RHODE ISLAND DEPARTMENT OF TRANSPORTATION

Great Island Br. #499

ADDENDUM NO. 1 Prospective bidders and all concerned are hereby notified of the following changes in the Plans, Specifications, Proposal and Distribution of Quantities for this contract. These changes shall be incorporated in the Plans, Specifications, Proposal and Distribution of Quantities, and shall become an integral part of the Contract Documents.

ADDENDUM NUMBER 1

UTILITY SUPPORT (US) DETAIL

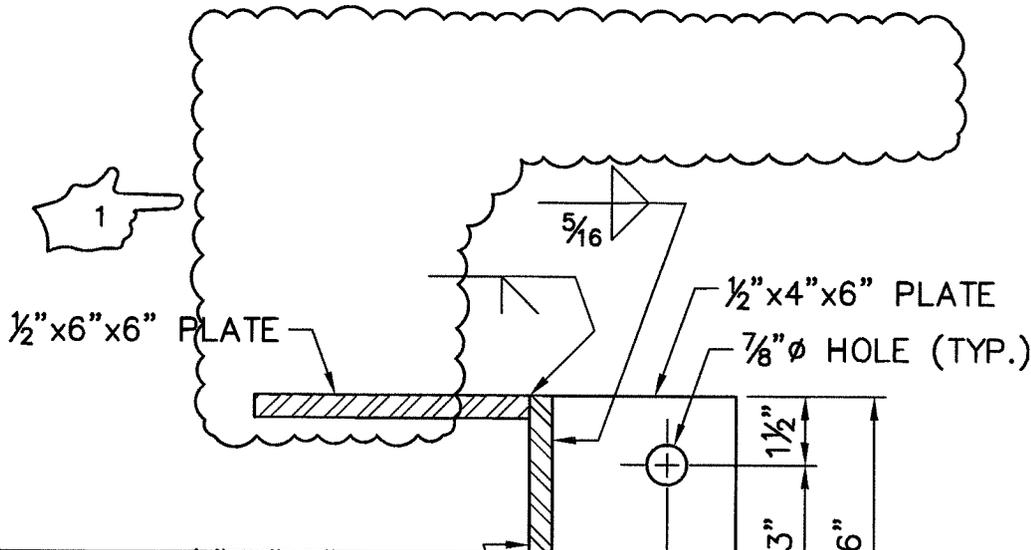
1. Sheet No. 16 – Framing Plan

Revise Sheet No. 16 as shown on Sketch No. 1(R-1) attached to this Addendum No. 1. The Utility Support Details have been revised.
